RE: EPPS BRIDGE ROAD FORCE MAIN UPGRADE

FOR THE OCONEE COUNTY UTILITY DEPARTMENT PROJECT NO. E14-229B

INVITATION TO BID#FY1706-15

ADDENDUM No. 1 Page 2 of 4

EXHIBIT ADD 1.1

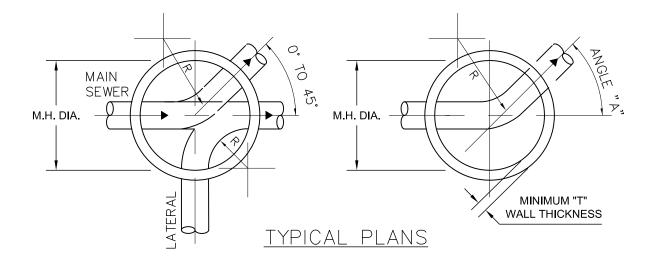
- a. A by-pass connection shall be installed on the new 12" force main at Sta 10+15+/-. The by-pass connection shall be constructed in accordance with attached Exhibit Add 1.1.
- b. The Bid Form (Section 00300) has been revised to include Item 11.10 for the by-pass connection.
- c. Measurement and Payment (Section 01025): The following item is added to Section 01025 for the by-pass connection:

EXHIBIT ADD 1.2

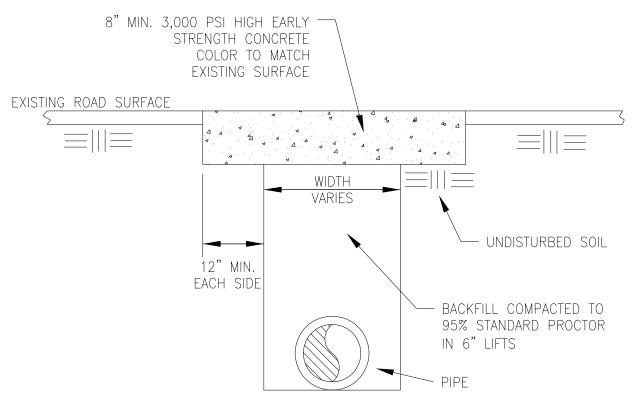
- (20) Manhole inverts shall be constructed in accordance with attached Exhibit Add 1.2.
- (21) Curb and Gutter Repair (Bid Item 8.04): Quantities are revised to include repair of 650 LF on Tanglebrook Drive and 6 LF at corner of Old Epps Bridge Road and Jennings Mill Parkway.

- 1. MINIMUM \mathbb{Q} RADIUS OF M.H. INVERT R = 1.5 x PIPE DIAMETER.
- 2. ROUND & TROWEL INVERTS SMOOTH.
